Questions and Answers
GAOA Grizzly Bear Campground
9 November 2026

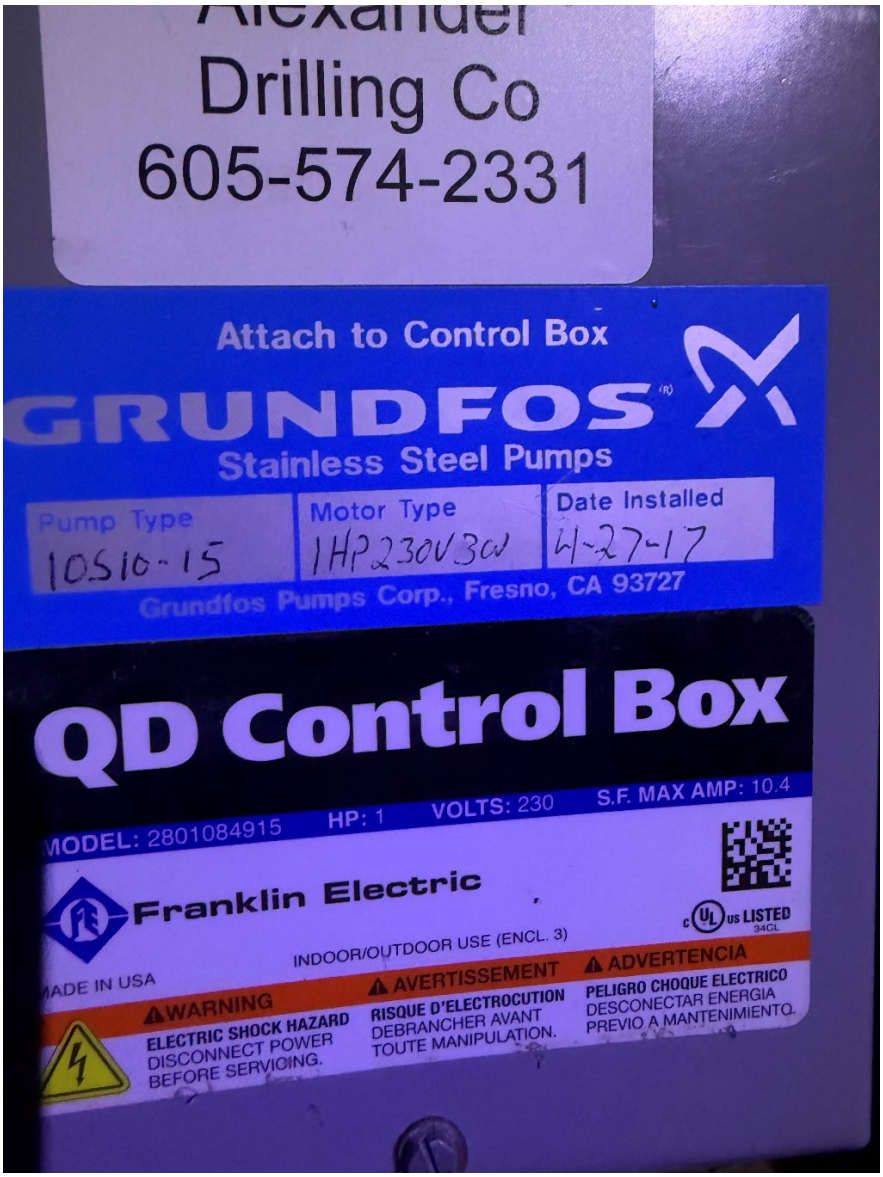
16. **Well pump data.** No drawing or spec gives the well pump horsepower, voltage or phase. Please provide the existing pump nameplate data and confirm the pump stays in place. E5.1 Detail A also shows a "supply pump" and "supply pump motor control box" next to the well pump control box. Is there a second pump? If so, please give its data and say whether it is new or existing. The existing submersible well pump is the only supply pump. It will be retained for the new system. Well pump nameplate is provided below:
